**BEFORE THE BOARD OF PATENT APPEALS
AND INTERFERENCES**

Application Number: 09/872,604
Filing Date: June 01, 2001
Appellant(s): CALLIES ET AL.

EXAMINER'S ANSWER

Figure 1 of Hane

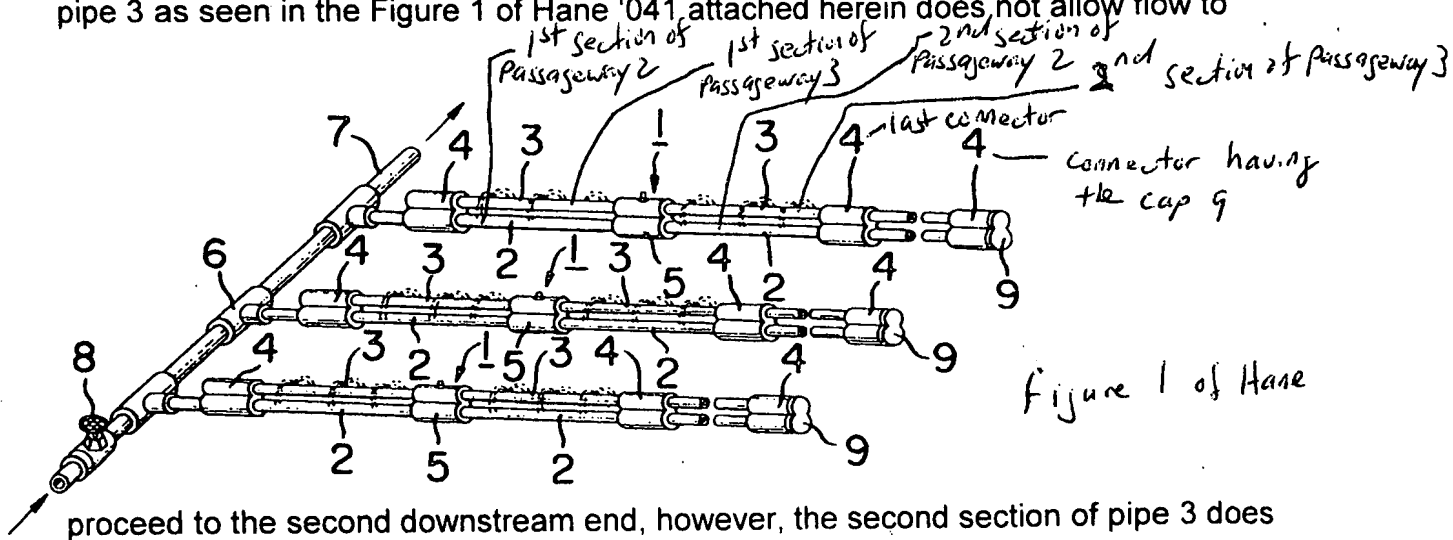
Appellant argues that claims 1, 3-9, and 14 are not anticipated by Hane (4,162,041). In the apparatus of Hane, water from main supply line 7 flows into first fluid passageways 2 and from each passageway 2 into second fluid passageways comprising hole 15 and pipe sections 3 (also considered as passages) via a fluid supply line 18 of connector 5 as seen in Figure 5. The examiner agrees that the first sockets 4 do not permit water flow from one sub-pipe segment 3 to the next segment 3, however, the second sockets 5 do permit such a flow via openings 13 in the sockets 5. As water from main supply 7 flows along one of the passageways 2, the water flows into the corresponding pipe (passageway) 3 via a supply line 18 connected to opening 13 of the connector 5 and proceeds to the second downstream end of pipe 3. The first section of pipe 3 as seen in the Figure 1 of Hane '041, attached herein does not allow flow to

proceed to the second downstream end, however, the second section of pipe 3 does permit the fluid to flow to the second downstream end through 18 as stated previously.

Thus, the combination of the first section of pipe 3, the connector 5, and the second section of pipe 3 permits fluid flow from the first upstream end to the second downstream end. Since Applicant's claim 1 recites "each passageway permitting fluid flow from the first upstream end to the second downstream end", the device of Hane meets this claim language since passageway sections of passageway 2 along with connector 5 permits fluid to flow from the first upstream end to the second downstream end as does the combination of the first and second sections of passageway 3 along with the connector 5.

Hane also shows a cap 9 attached to a socket 4 as seen in Figure 1 of Hane '041 attached herein. The apparatus of Hane as seen in Figure 1 alternates a connector 4, a connector 5, and another connector 4. If the last connector 4 (the one farthest from the main supply 7) is capped with cap 9, then the water flows from the upstream end (end near the main supply 7) to a second downstream end which has the capped connector. The connector 4 having the cap as seen in Figure 1 is actually not a part of the apparatus of Hane since it is only there to teach that the last connector of the apparatus of Hane would have a cap 9. Thus, for a relatively shorter field to be irrigated, one having ordinary skill in the art would recognize that there may not be a requirement for additional connectors 5 and that the last connector 4 could be capped with a cap 9. Since the Applicant is claiming "fluid passageways", the sections of 3 in conjunction with holes 15 of the connectors 5 form a "fluid passageway" that permits flow from the upstream end of the apparatus to the downstream of the apparatus as stated above. Therefore, the apparatus of Hane comprises more than one fluid passageway throughout

its length-one formed by the sections of passageway 2 which are fluidly connected to each other via connector 5 and a second passageway formed by the combination of the sections of passageway 3 along with the hole 15 of connector 5 as stated above.

Regarding Applicant's argument that Hane does not show a second fluid supply separate from the first or main supply line, the examiner respectfully disagrees because water from pipes 2 flows into pipes 3 via flow passage 18 of connector 5 and thus passage 18 is a second fluid supply line which supplies water to pipes 3. The Applicant has not claimed further limitations of the "second fluid supply line" itself. The passage 18 of connector 5 can also be considered as an "alternate supply."
